PRINCE EDWARD COUNTY ADDENDUM No. 2

Date: Tuesday, April 16, 2019
Contract: 2019-EDW-01
**AMELIASBURGH WATER TREATMENT PLANT PROCESS
PIPING UPGRADES**

Image 1

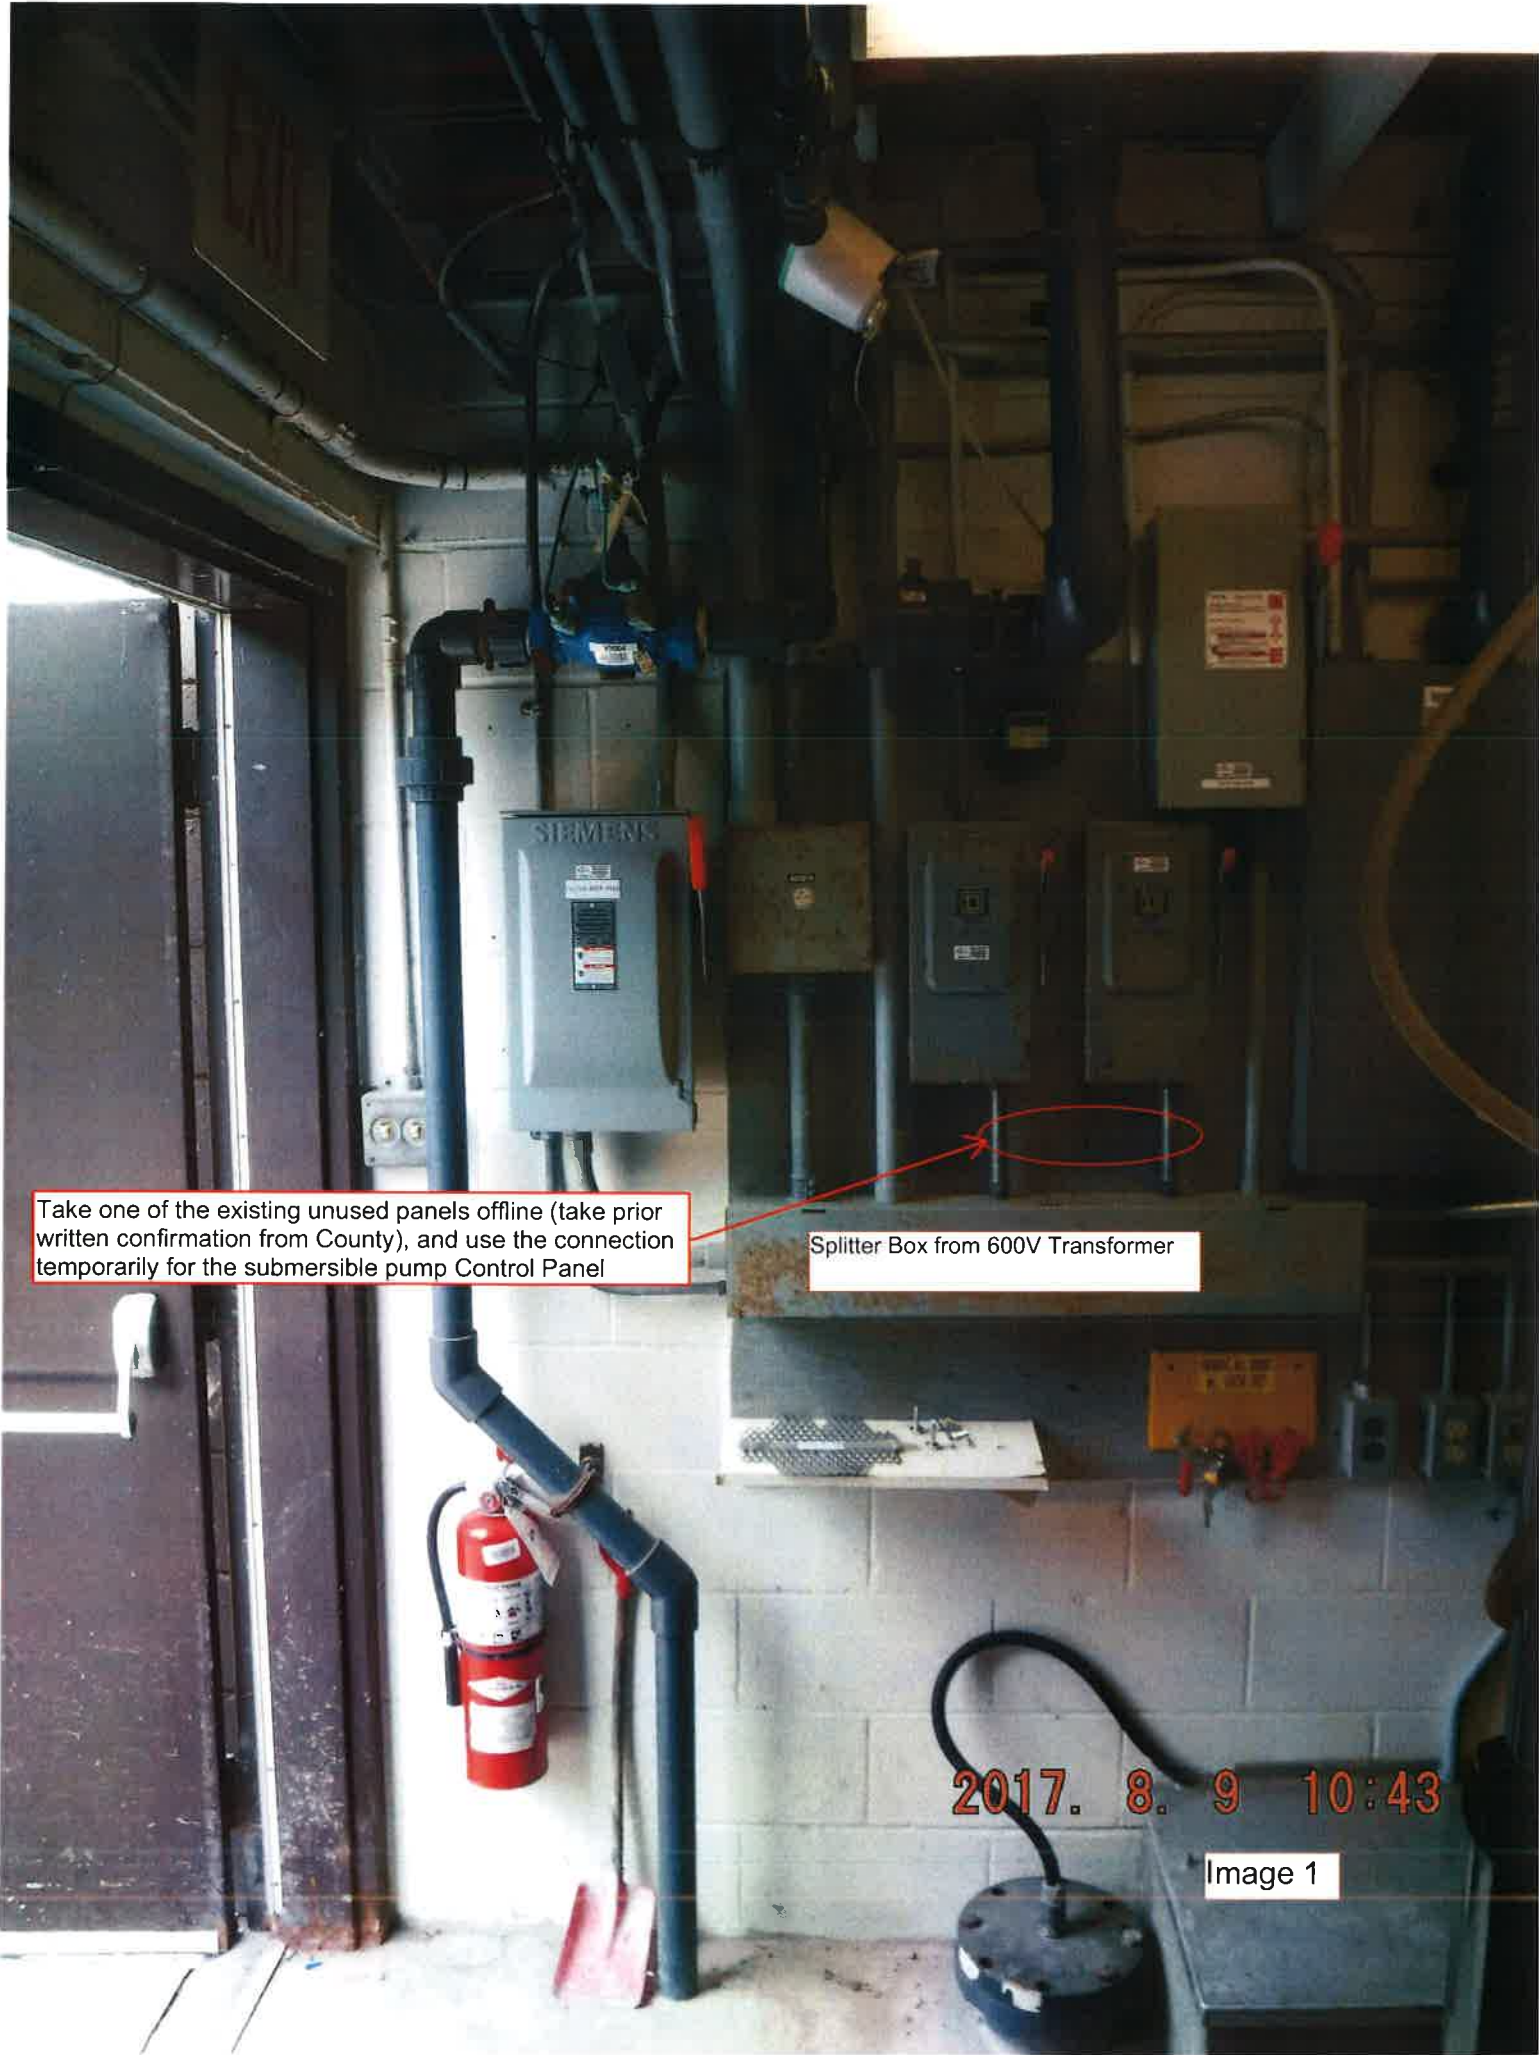
- 1. Question:** Section 11316 Submersible Pumps calls for the supply of temporary submersible pumps for use during plant shutdowns, pumping water from the backwash supply tank to the effluent pipe during backwash, or other longer-term shutdowns. The pumps are to be turned over to the County at completion of the project for their use. These pumps are specified to be 575V, 3phase, 60Hz. Drawings do not show where 575V power can be obtained from for these pumps. Please provide electrical tie-in information for the pumps.

Response: Refer to added marked-up image 1 showing Splitter Box and Panels for information regarding electrical tie-in information.

Take one of the existing unused panels offline (take prior written confirmation from County), and use the connection temporarily for the submersible pump Control Panel

Splitter Box from 600V Transformer
